1805 LARCH STREET
APPLICATION FOR DEVELOPMENT PERMIT

APPLICATION FOR DEVELOPMENT PERMIT & RESPONSE TO CONDITIONS OF APPROVAL

Response to Conditions of Approval of the Form of Development

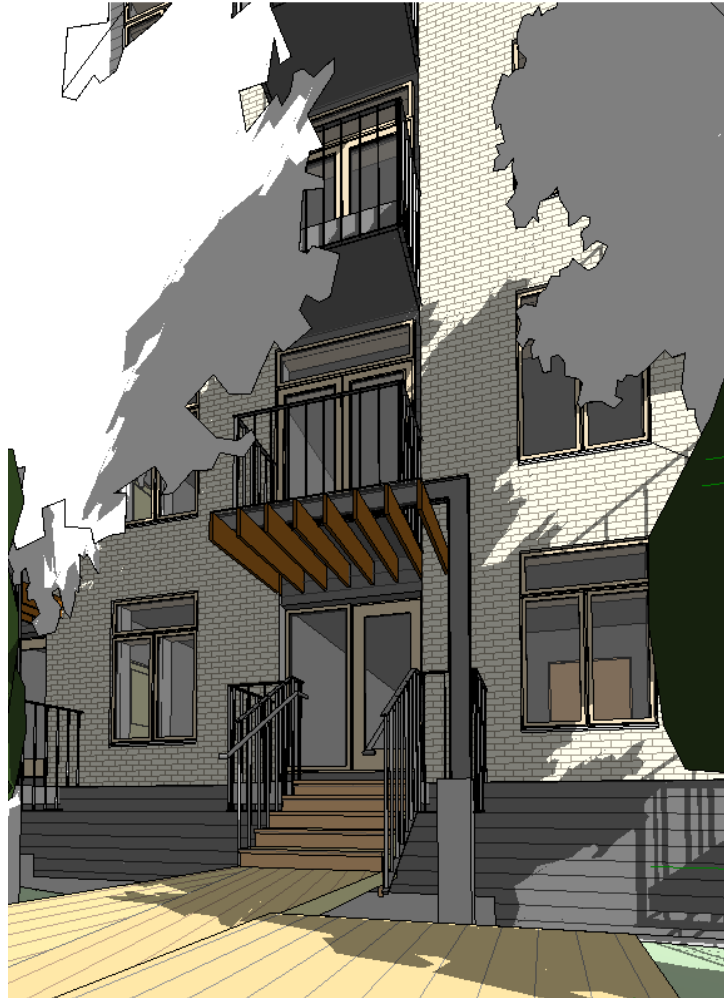
5(b) Articulating the building facades to better relate to the scale and proportion of the surrounding buildings;

Note to Applicant: The proposed massing does not have any variation to the wall planes. This condition is to encourage a more sensitive design approach, which may be achieved by incorporating varied setbacks, colour and material changes, and projections and voids to enhance the overall architectural expression.

Articulation of the elevations has been significantly reinterpreted in this Development application. Staff had commented on the previous monolithic design, and therefore we have been careful to break up the large planar wall section and mass and allow for more compatible and sympathetic facade. The Elevations step in and out at the corners and balconies with material change from brick to lap siding, adding a depth and layering complexity akin to buildings adjacent and of an earlier era.

Roof Top Amenity: Looking from above at Corner of Larch & West 2nd Ave

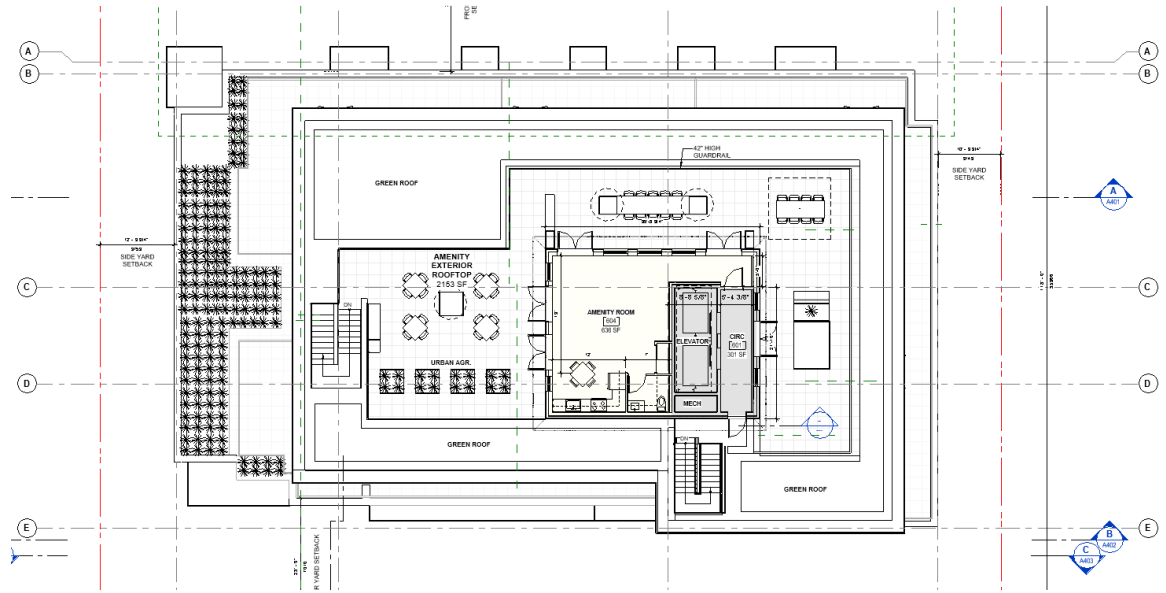
- 6(a) Design development to provide an amenity room commensurate with the number of rental units.

Note to Applicant: The intent is to accommodate a range of activities and gatherings for adults and children on site. The amenity room must include an accessible washroom, a kitchenette and a storage room and should be approximately 600 sq. ft. in area.

Recommend co-locating the amenity room with the outdoor amenity space on the rooftop, provided the amenity room is centrally located and set back from the edges of the building to minimize overlook and visibility from the street and lane.

The Amenity room is 630 sq ft with extensive kitchen, accessible washroom facilities and ample outside space for families to play, relax, eat and garden in a 2,200 sq ft. 360 degree safe space. This area has been redesigned to sit inboard of the building mass so as not to impact privacy and further reduce perceived height and mass.
